Access Compliance Report

Public Rights-of-Way

(Curb Ramps)

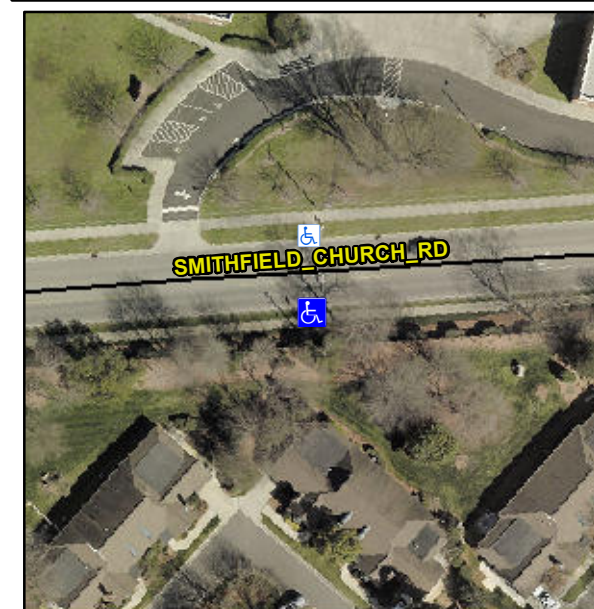
Intersection ID: 10038266	Main Street: SMITHFIELD_CHURCH_RD	Cross Street: N/A	Location: S
ADA ID: CEB39FBD0375	Ramp Type: Perp	Initial Pass/Fail: Fail	Overall Compliance: No
Codes/Mitigation Info/Possible Solution		Field Measurements/Component Compliance	
Severity Score: 25

PROW/ADA:

Not Found, R304.2.2

Possible Solutions:

Remove & Replace Entire Ramp.
